PO#2602--FOUNTAIN--Gate style #20----- thickness: 2-1/4"

PROWELL Woodworks  
8 0 0 . 4 6 6 . 1 8 5 0

Dated: Jan. 6, 2026

GATE #1

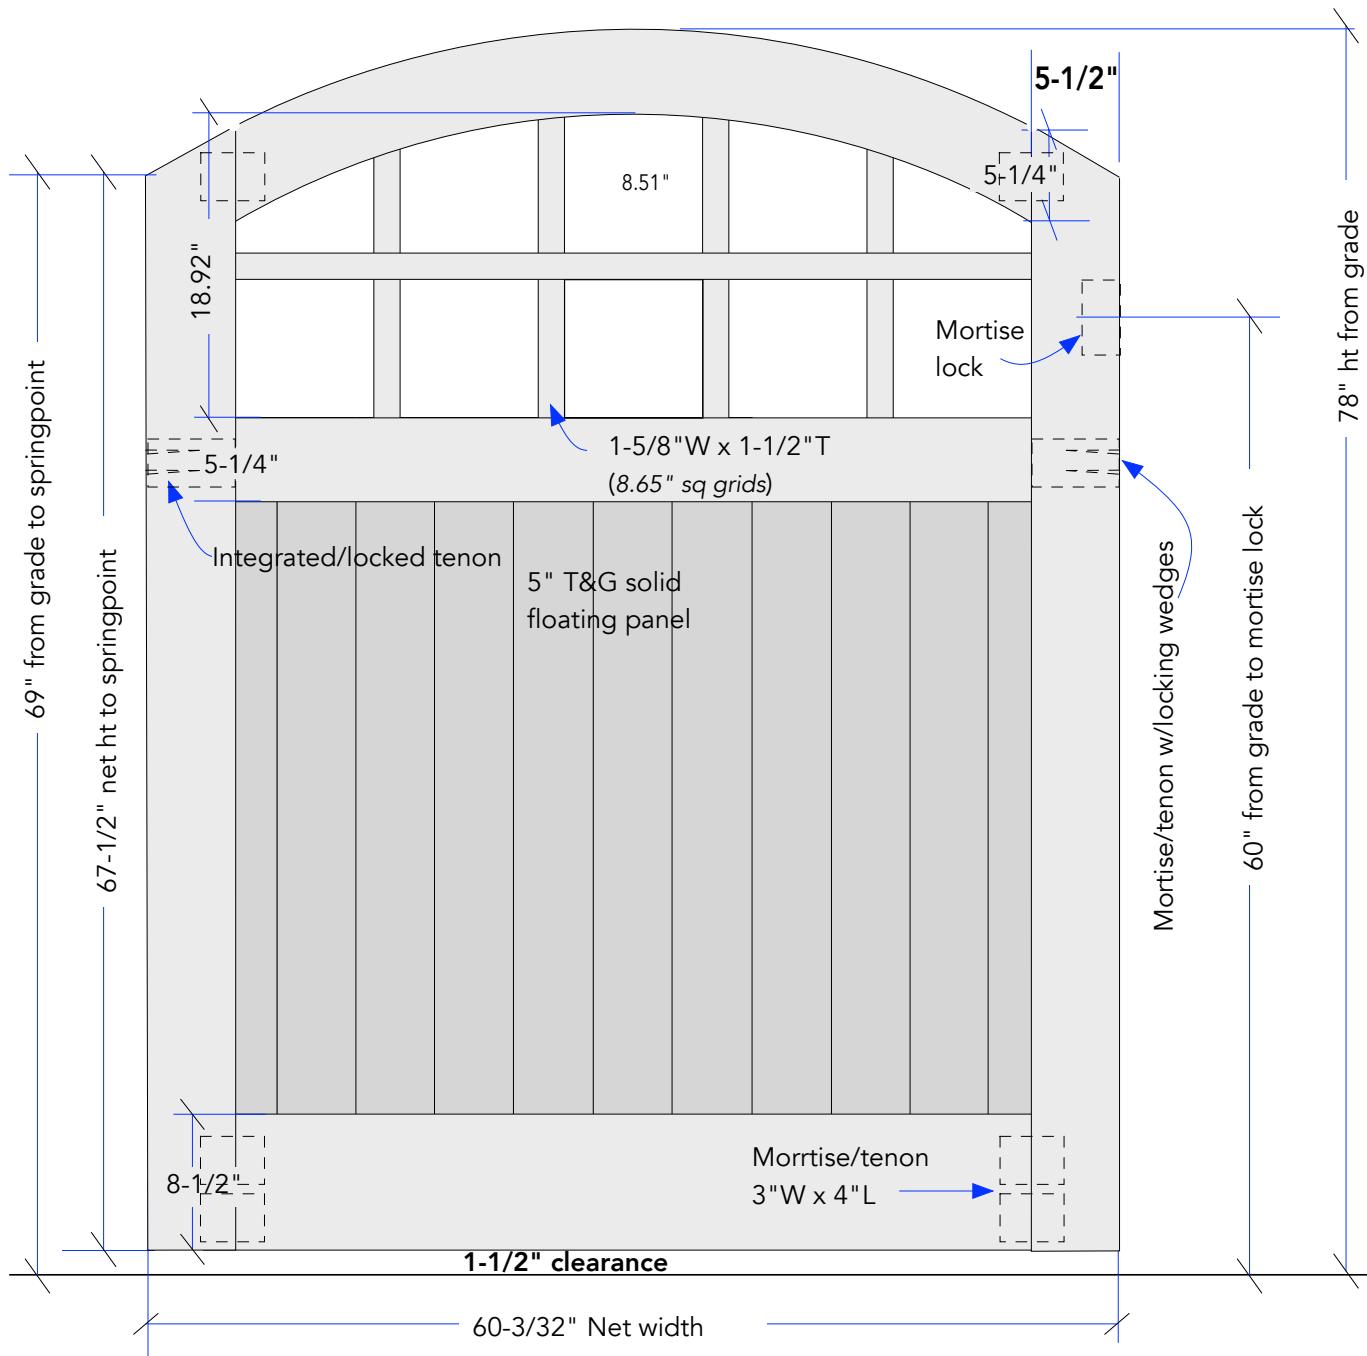
Jan 6 revisions:

- \*Revised net ht to 60-3/32"
- \* Changes the grid size to 8.51"
- \*Bottom clearance of 1-1/2"

GATE #2  
Exterior Front Right Main Gate

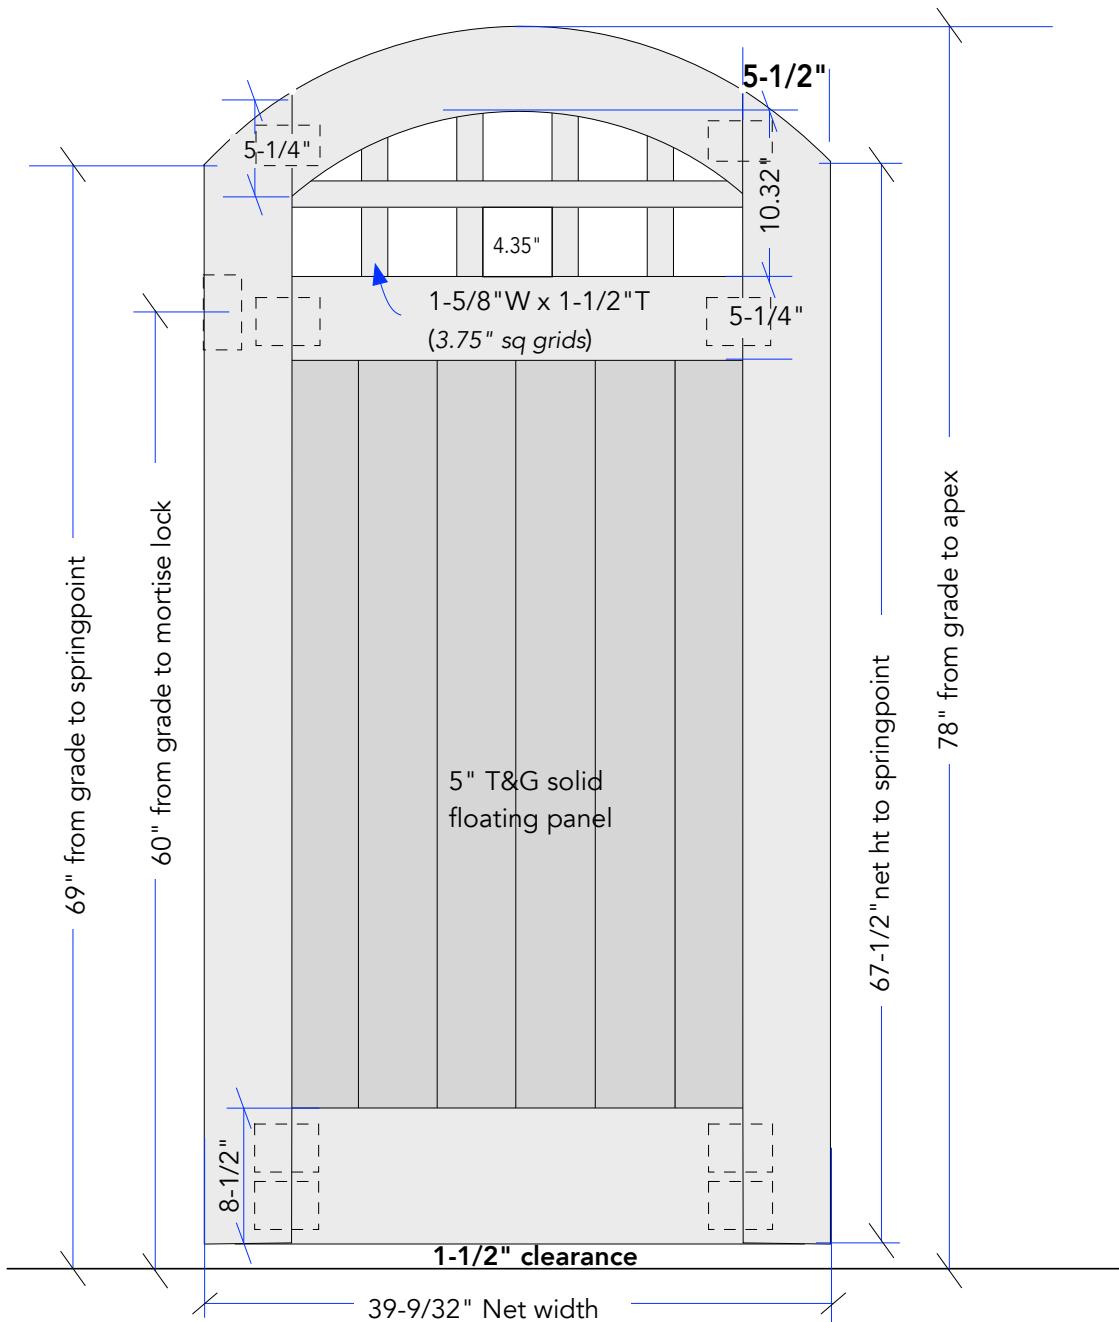
Revisions:

\*Bottom clearance of 1-1/2"

GATE #3

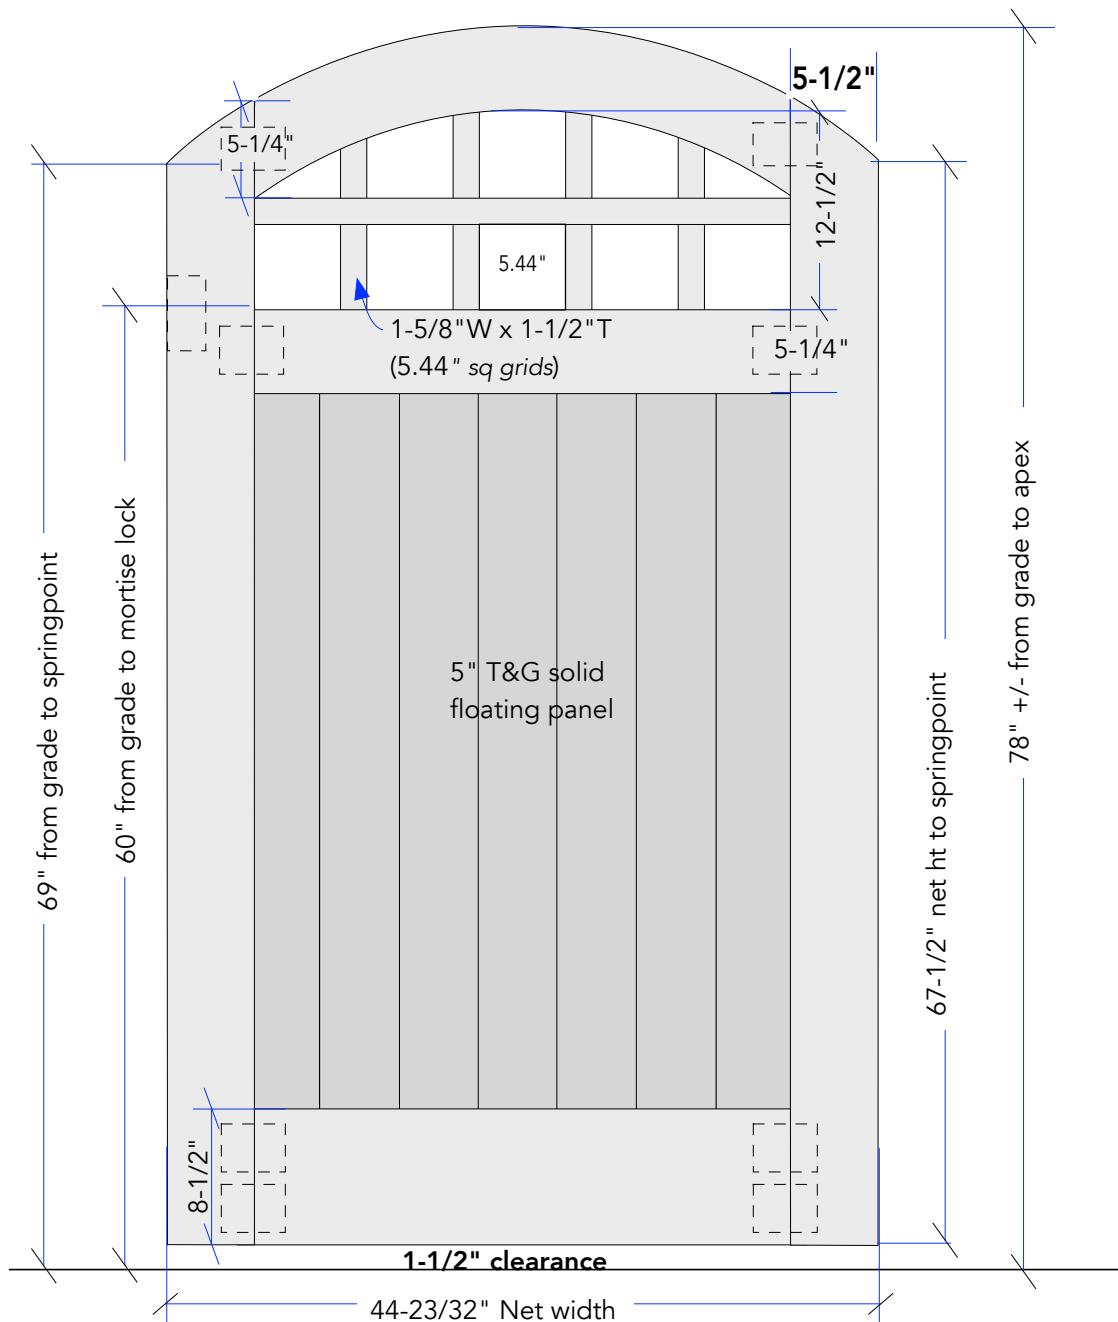
Revisions:

\*Bottom clearance of 1-1/2"

GATE #4

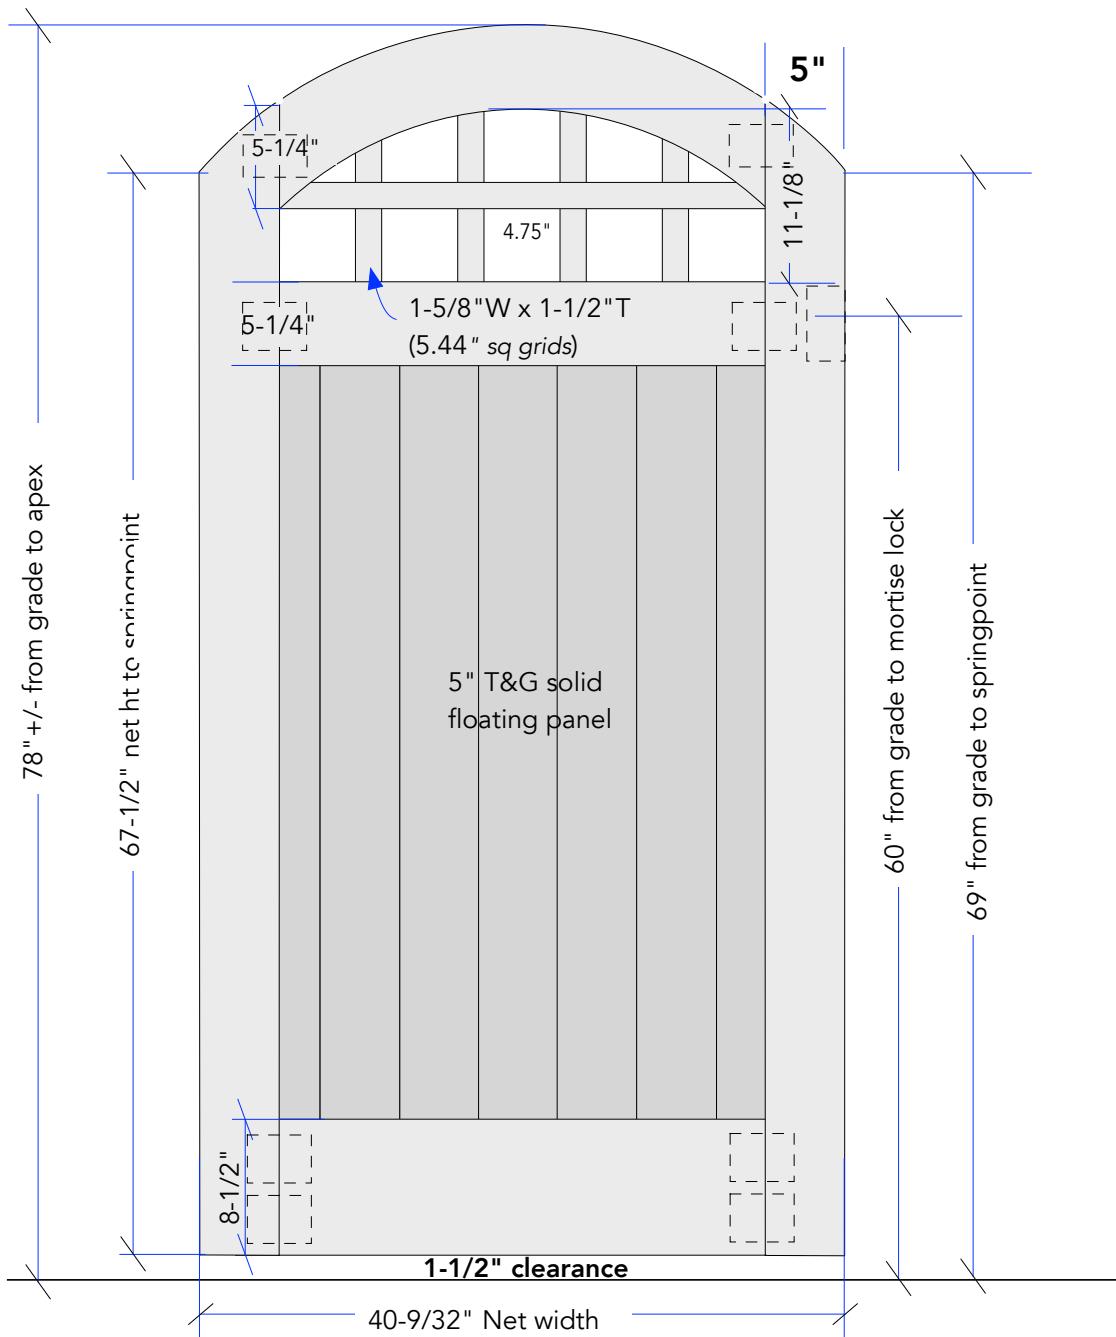
## Revisions:

\*Bottom clearance of 1-1/2"

## GATE #5

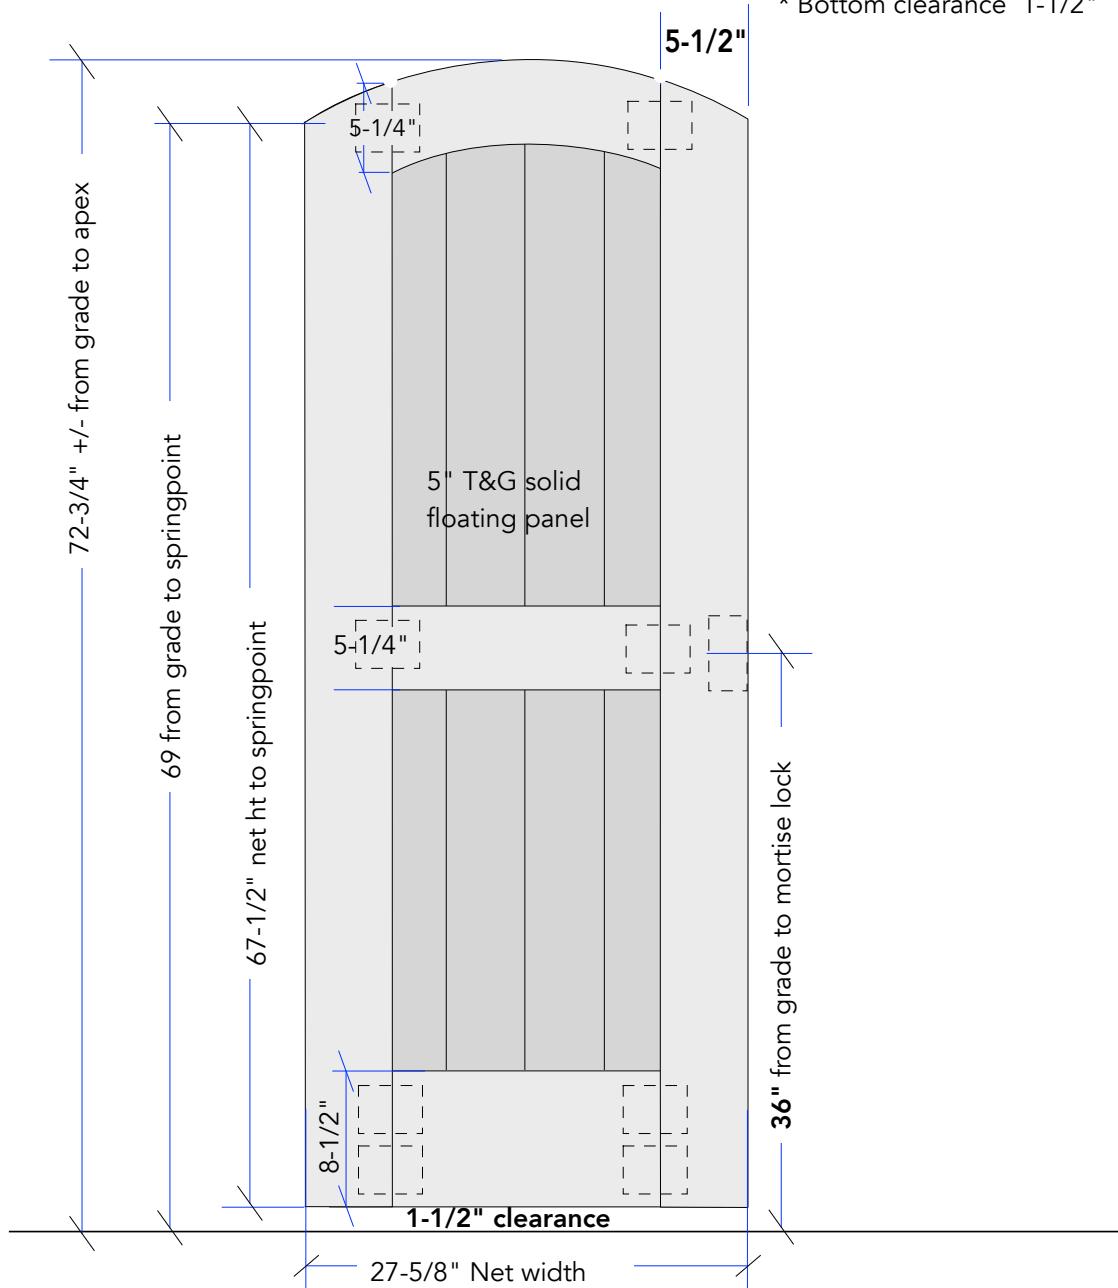
Jan 6 revisions:

\*Revised upper grid to solid T&G.

(Less \$165)

\*Mid-rail centered at 60" from grade.

\*Mortise lock to 36" from grade

\* Move lock-mid-rail to center at 36" from grade

\* Bottom clearance 1-1/2"
